Planning Application No. A/K5/878
Section 16 Planning Application for Proposed Minor Relaxation of Building Height Restriction
for Permitted 'Religious Institution' and 'Social Welfare Facility' Uses,
at NKIL Nos. 3635 RP and 3762, 43 - 45 Berwick Street, Sham Shui Po, Kowloon

Submission of Further Information

**Section 16 Planning Application for Proposed Minor Relaxation of
Building Height Restriction for Permitted 'Religious Institution'
and 'Social Welfare Facility' Uses, at NKIL Nos. 3635 RP and 3762,
43 - 45 Berwick Street, Sham Shui Po, Kowloon**

Responses-to-Comments

Section A-A [1:200] (*For Indicative and Illustrative Purposes Only)
 Technical Feasibility Study - Hong Kong Sheng Kung Hui St. Thomas' Church Redevelopment under Special Scheme on Privately Owned Sites for Welfare Uses (Special Sites Scheme)

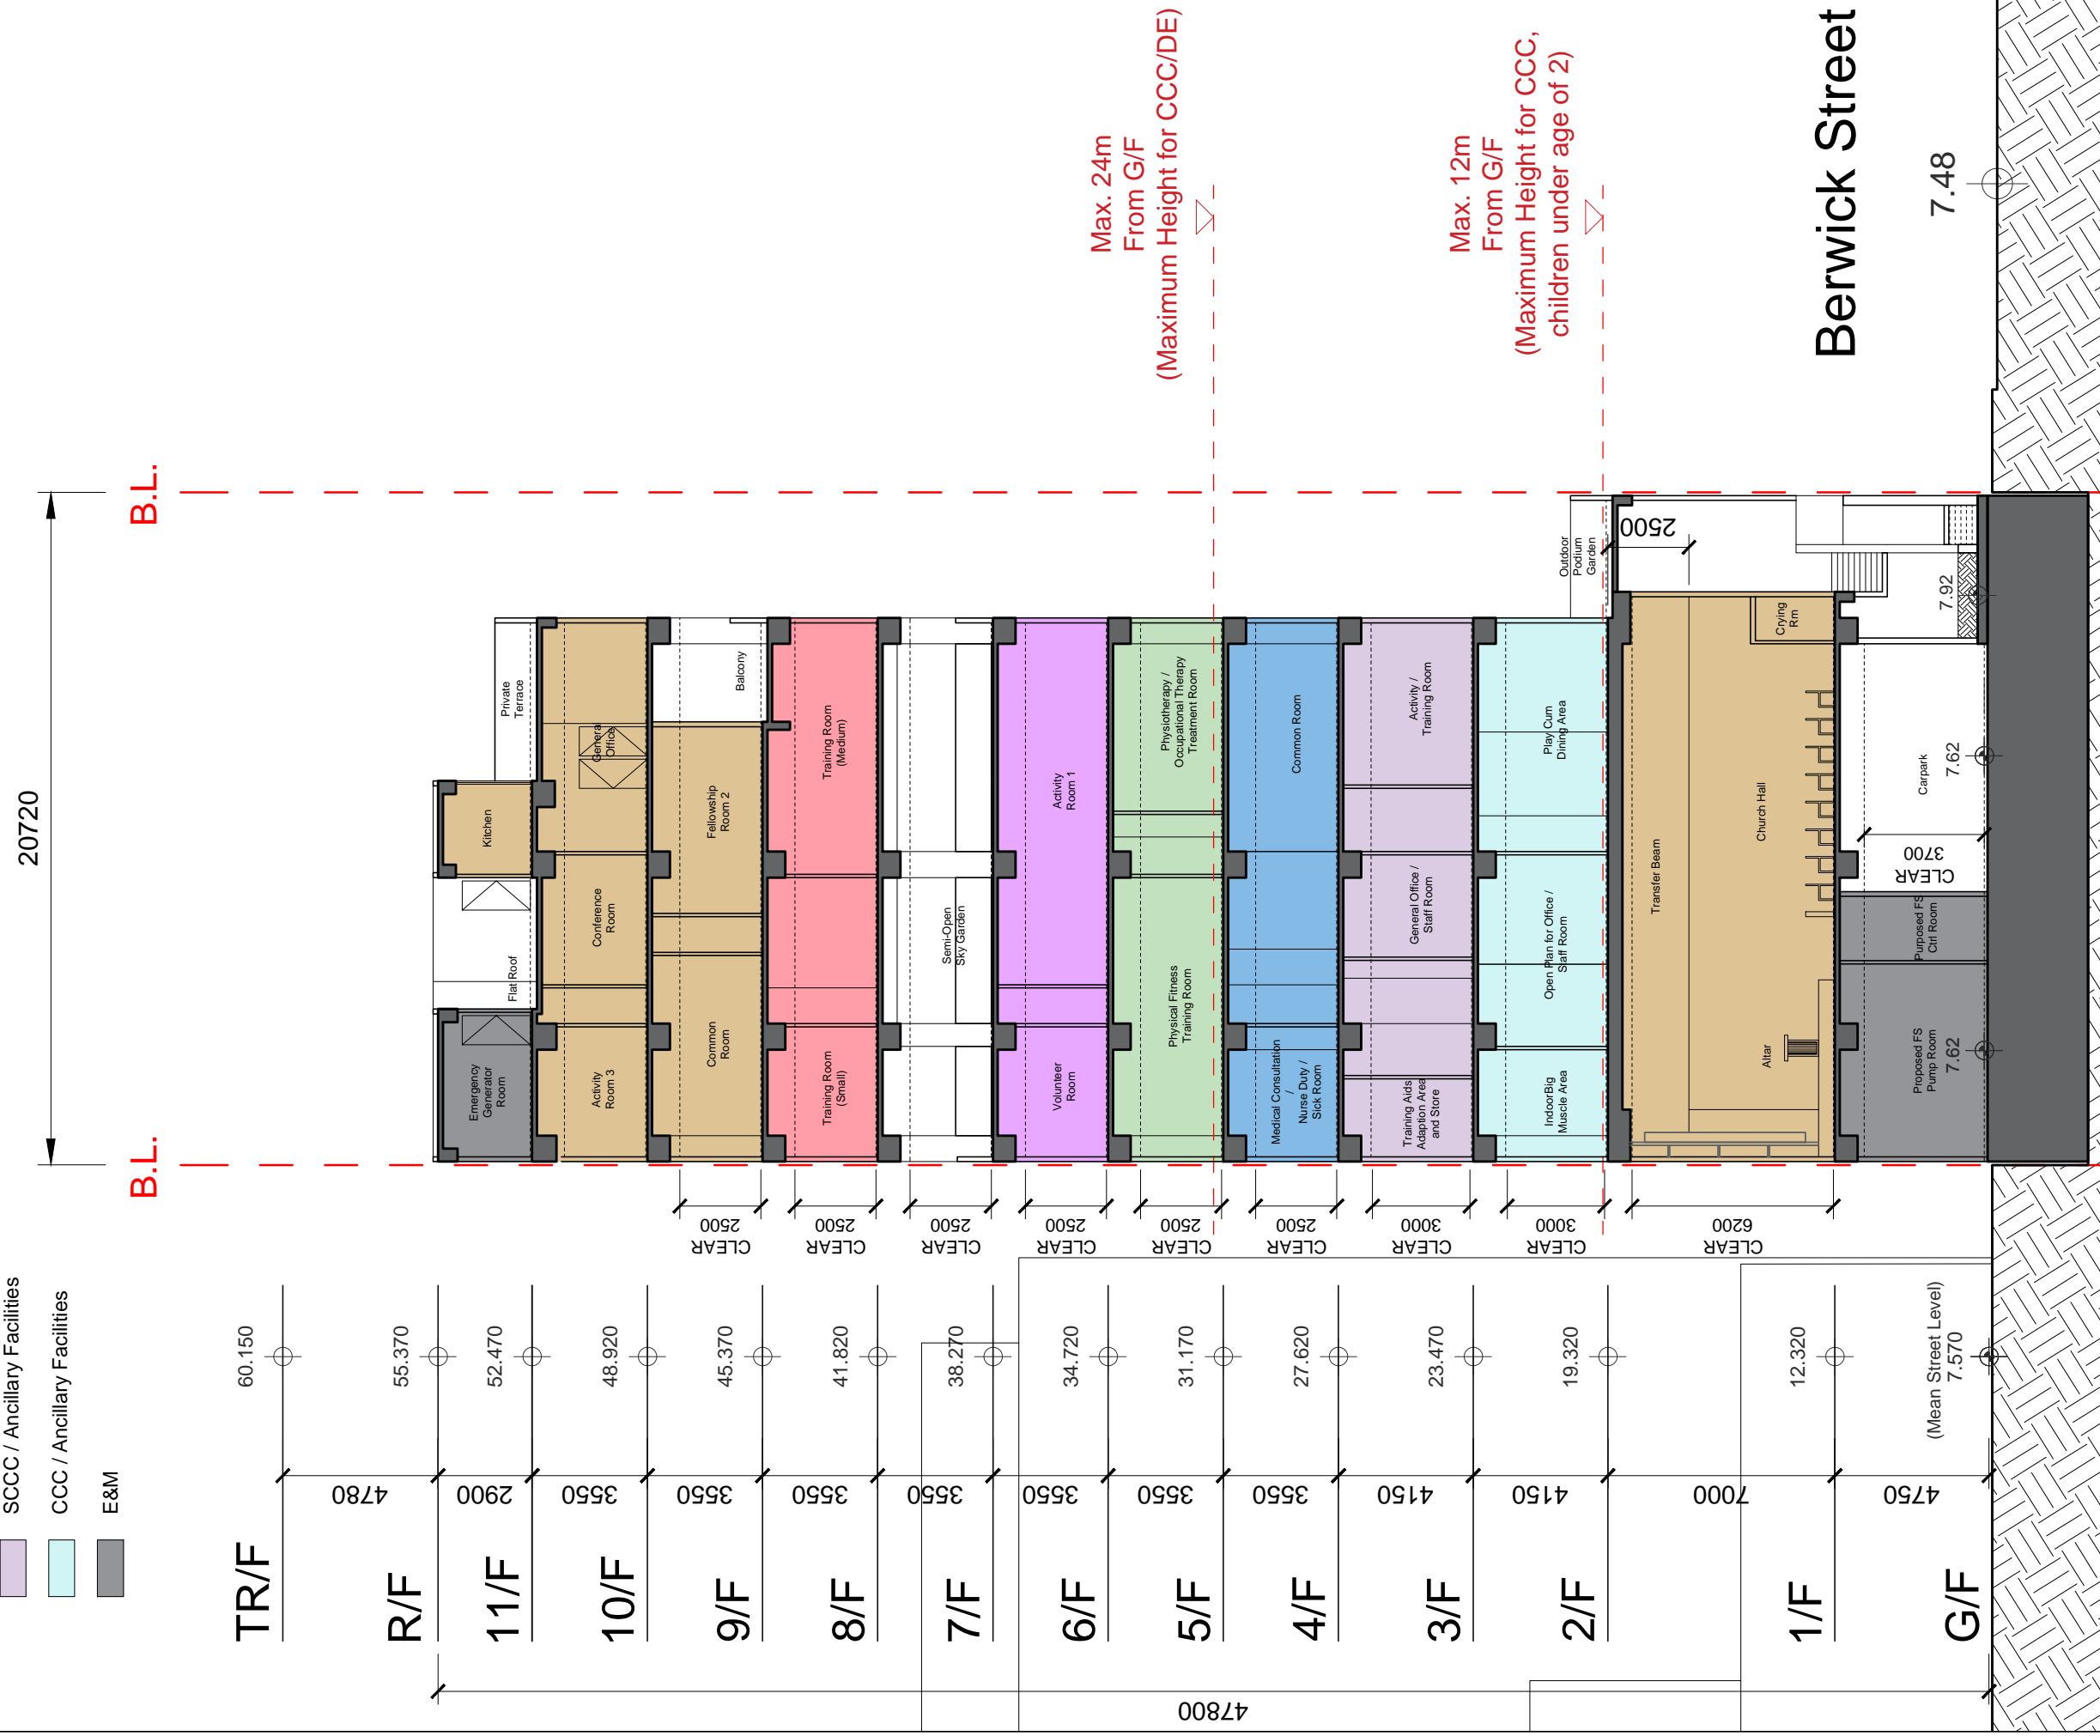
Annex 2 - Architectural Drawings		
12.	Section Drawing nos. 01, 02, A-A, B-B and C-C - Please review if "Other Use" stated in the legend should read as "Ancillary Facilities".	Noted and revised. Please refer to Annex 4 of this FI submission.

PROJECT NO.	TITLE
	PPCL-PLG-10128	Artist's Impression on Footpath Widening of Portion of Berwick Street fronting the Application Site

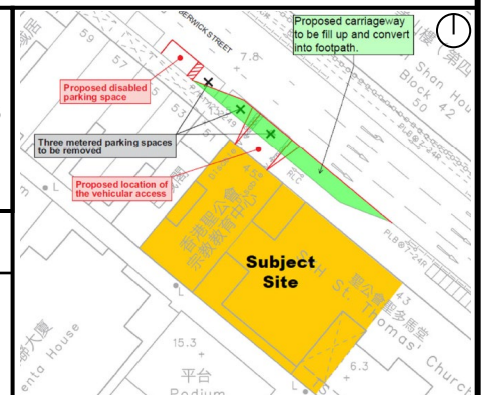
13.	Drawing on "Artist's Impression on Footpath Widening of Portion of Berwick Street fronting the Application Site" – Please highlight the extent of footpath widening proposal on the plan.	Noted and revised. Please refer to Annex 4 of this FI submission.
Annex 3 - Landscape Drawings

Approx. 7.4m wide set back

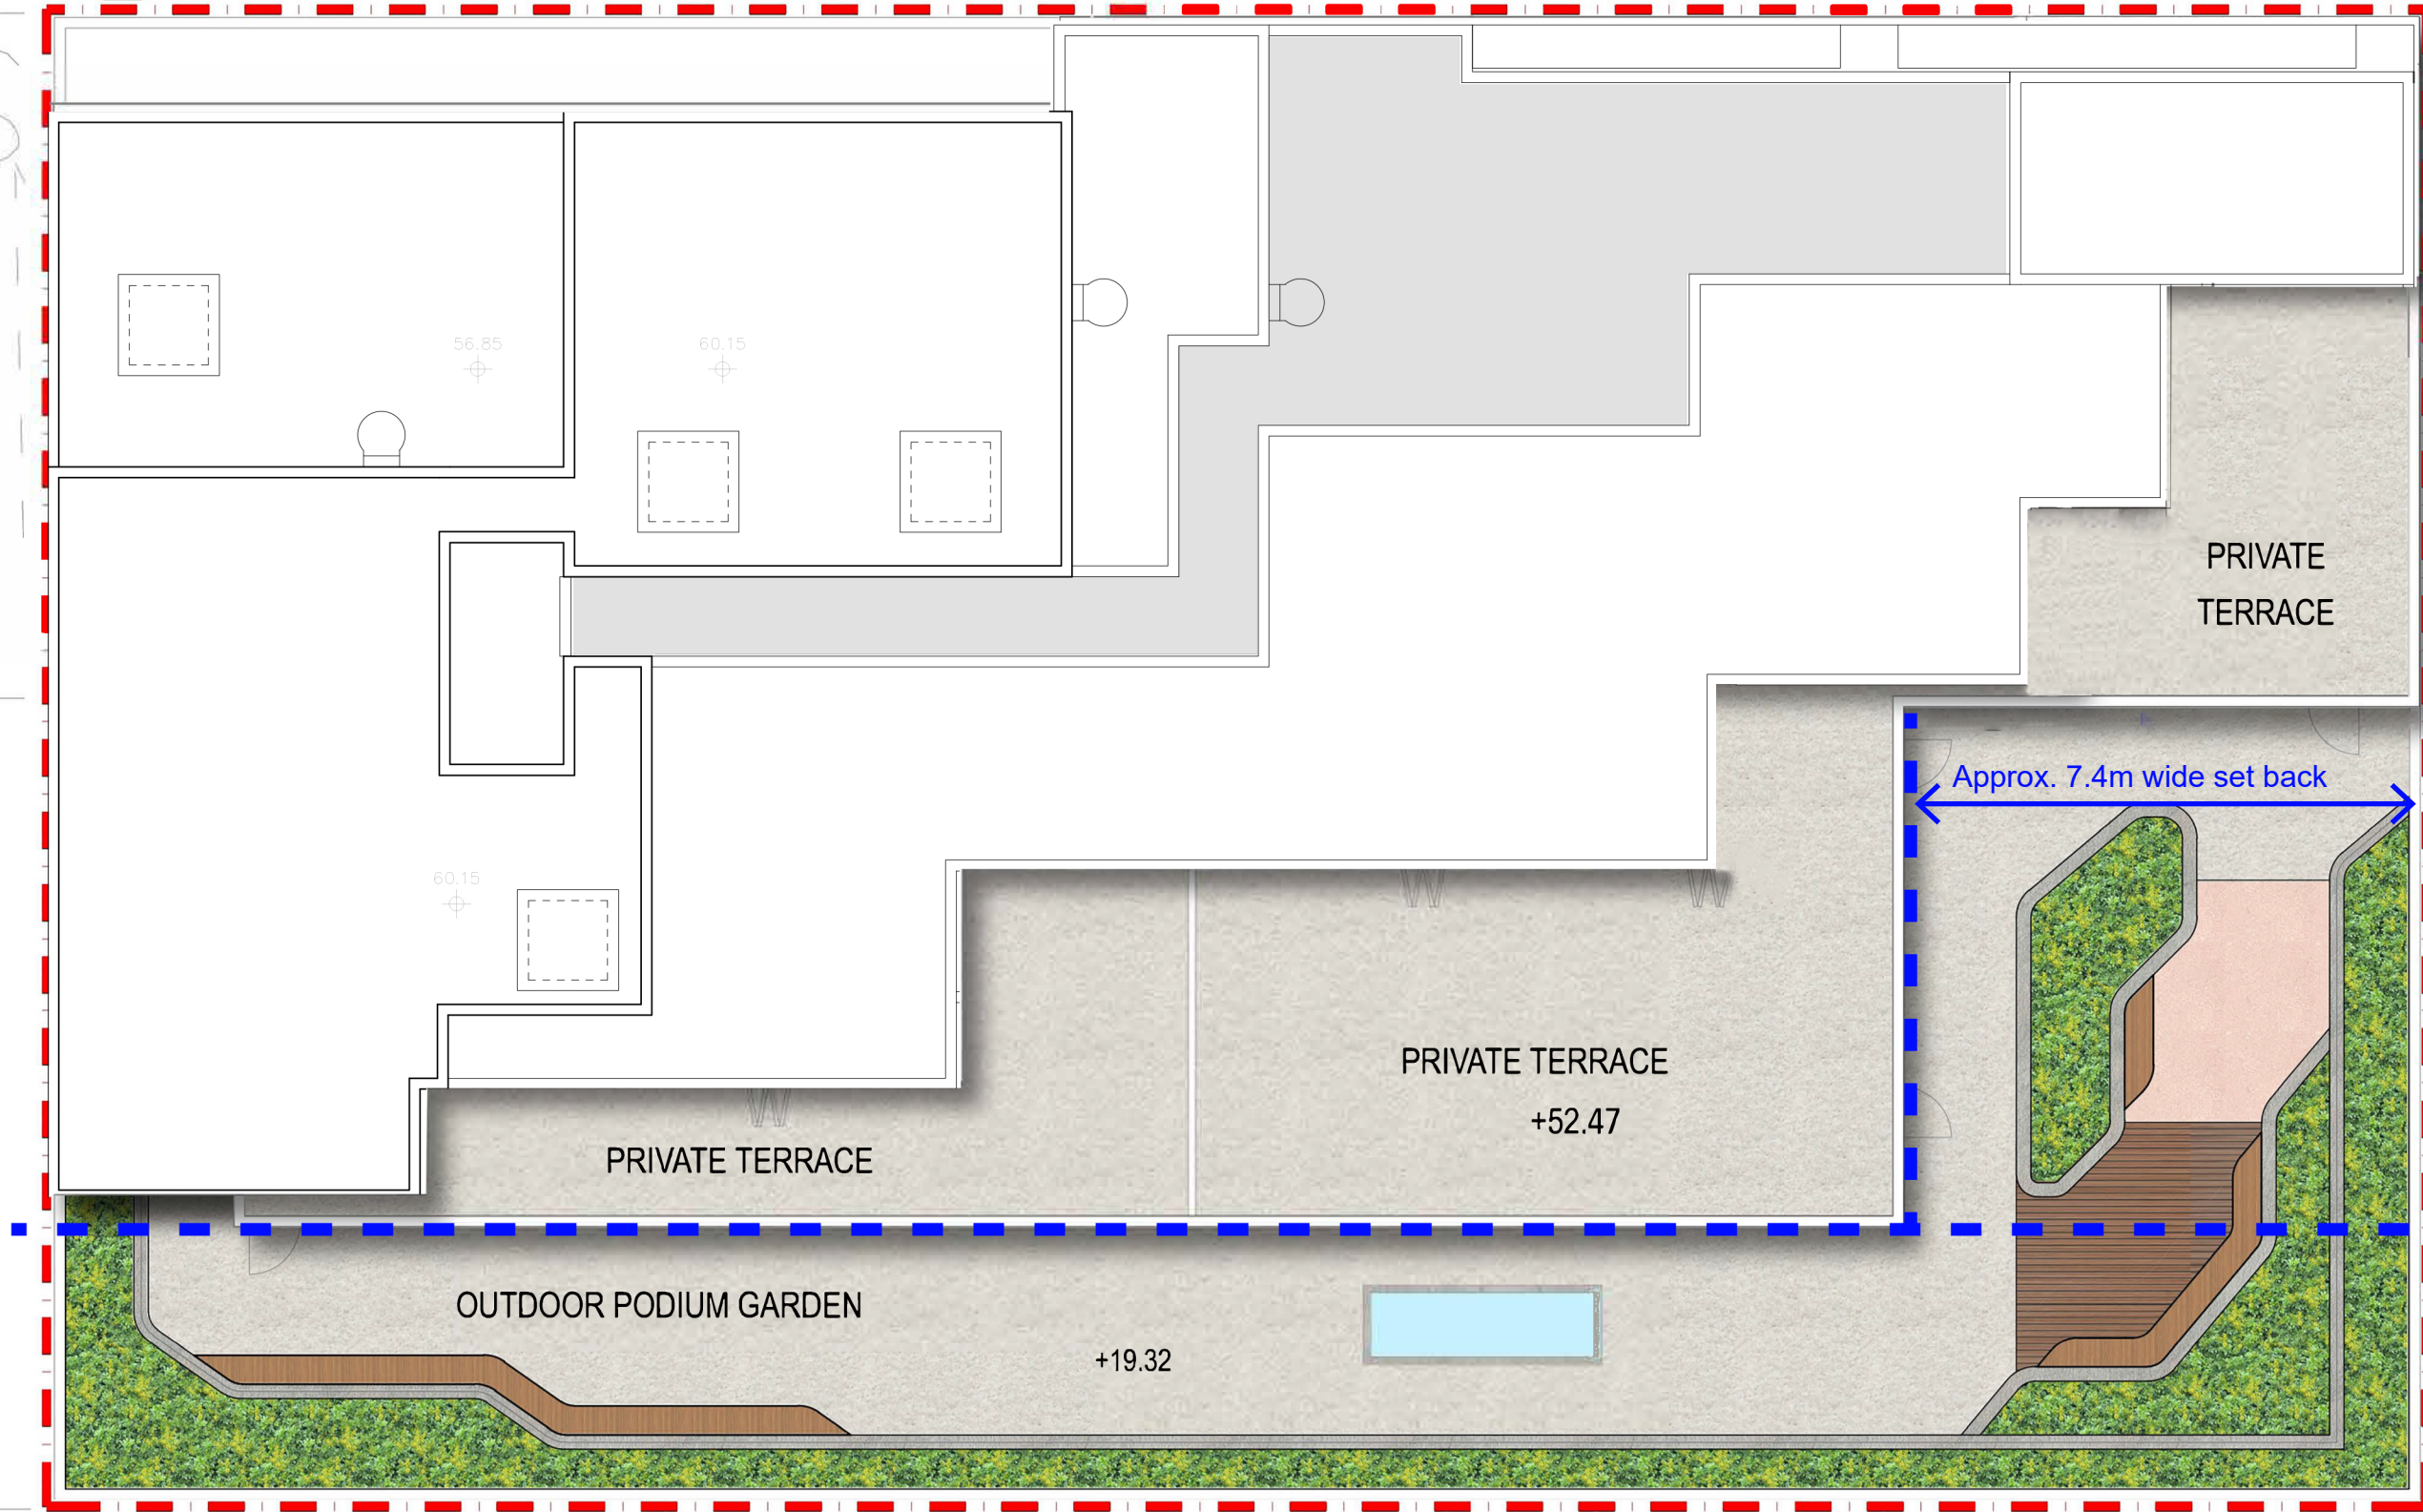
Item	Departmental Comments	Applicant's Responses						
15.	Please review the indications of setback areas in relevant plans.	Noted and revised. Please refer to Annex 5 of this FI submission.						
Annex 4 - Visual Impact Assessment								
16.	Figure 5.5 – It seems that photos for View Point 5 is relatively outdated as compared to the photo for View Point 2. Please revise.	Figure 5.5 is updated. Please refer to Annex 6 of this FI submission.						
17.	Please review the building massing of the subject redevelopment in Figure 5.6	Figure 5.6 is updated. Please refer to Annex 6 of this FI submission.						
18.	Please use photomontage(s) to demonstrate the visual impacts from the relevant strategic viewing points.	Noted and relevant information has been supplemented in the VIA. Please refer to the replacement page and additional Figures 6.1 and 6.2 for the VIA in Annex 6 .						
4. Comments from Drainage Services Department (Contact Person: Timothy KWAN, Tel: 3965 8972)								
2.	Please substantiate the assumed population with the corresponding floor and GFA. EPD's advice shall be sought on the method of sewage flow estimation.	The population estimation for Proposed Redevelopment and other catchments are calculated in accordance with the EPD's Guidelines for Estimating Sewage Flows. Please note the SIA is also copied to EPD for review. Please refer to the replacement pages of SIA in Annex 3 .						
3.	Section 7.2 – Checking of sewerage system shall include the sewer from FMH4017041 to FGJ4000740.	Hydraulic calculation for sewer from manholes FMH4017041 to FGJ4000740 has been included. Section 6.4, Section 7.2 and Appendix 7-1 have been updated accordingly. Please refer to the replacement pages of SIA in Annex 3 .						
5. Comments from Urban Design and Landscape Unit of Planning Department (Contact Person: Justin HO, 3565 3937)								
Detailed comments on planning statement (PS) and VIA:								
PS								
(i)	Para. 5.8.2 – Referring to our comments below, this para should read "...could be regarded as 'negligible' to 'slight to moderate' when compared...".	Noted and revised. Please refer to Annex 1 of this FI submission.						
VIA								
(ii)	As raised in our previous comments dated 16.3.2026 during the pre-submission stage, the VIA shall be updated with reference to TPB PG. No. 41A as follow:							
	<ul style="list-style-type: none"> Para. 1.2.5 and Table 1.2 – The resultant overall impact should be classified into five levels of significance as "beneficial", "negligible", "slight", "moderate" and "substantial". 	Noted and revised. Please refer to Annex 6 of this FI submission.						
	<ul style="list-style-type: none"> Section 5 and Table 5.1 – <ul style="list-style-type: none"> (i) The terminology of the overall visual impact ratings of the following VPs should read:

Section A-A

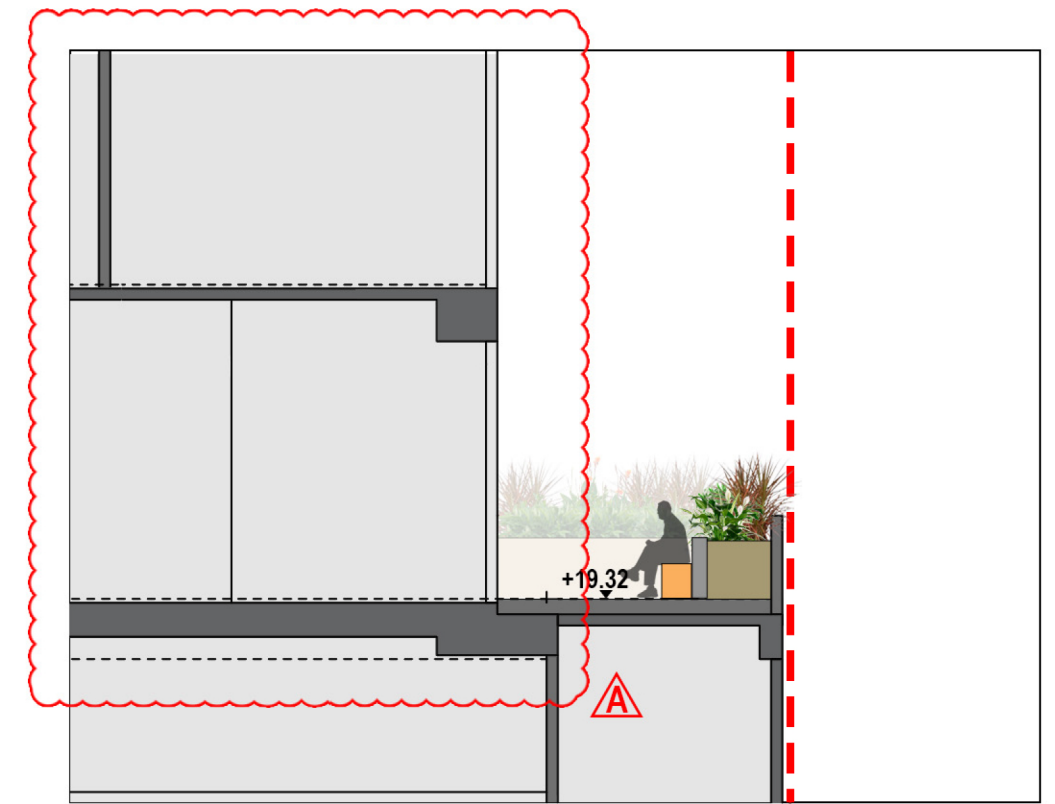
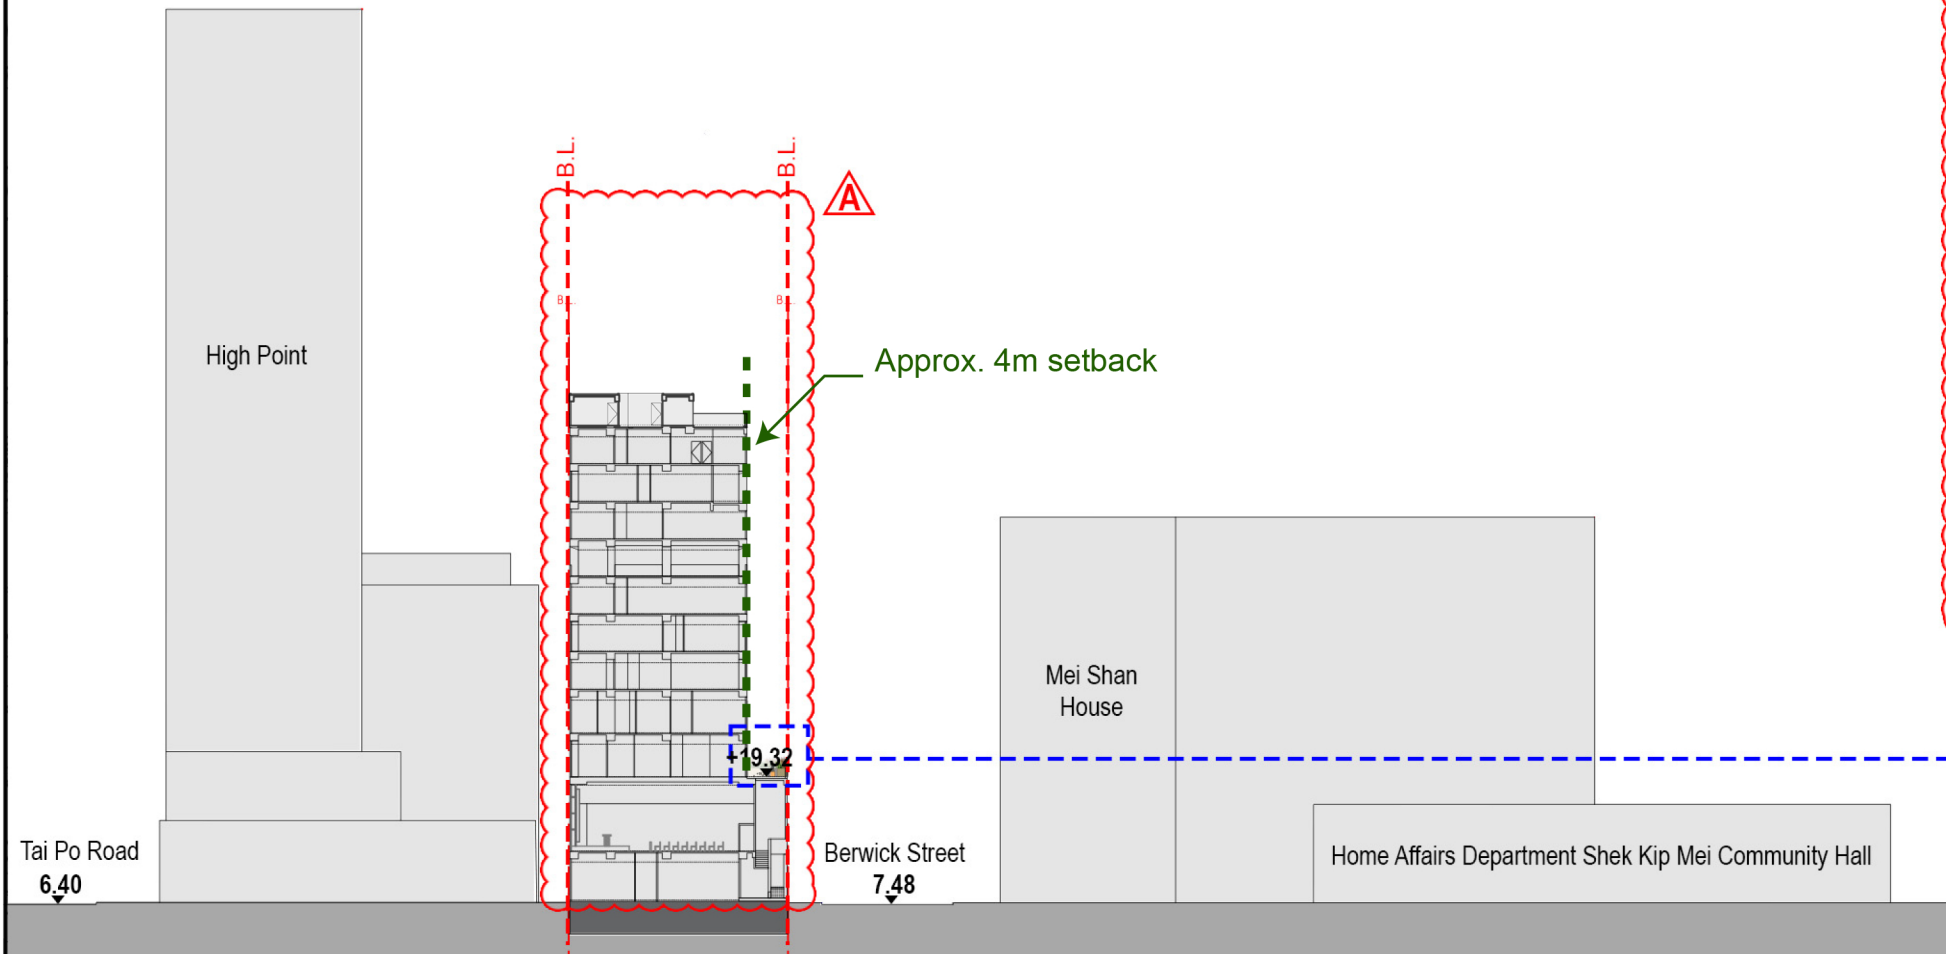
14.	Please review the building height in the Drawing "Landscape Section A".	Noted and revised. Please refer to Annex 5 of this FI submission.
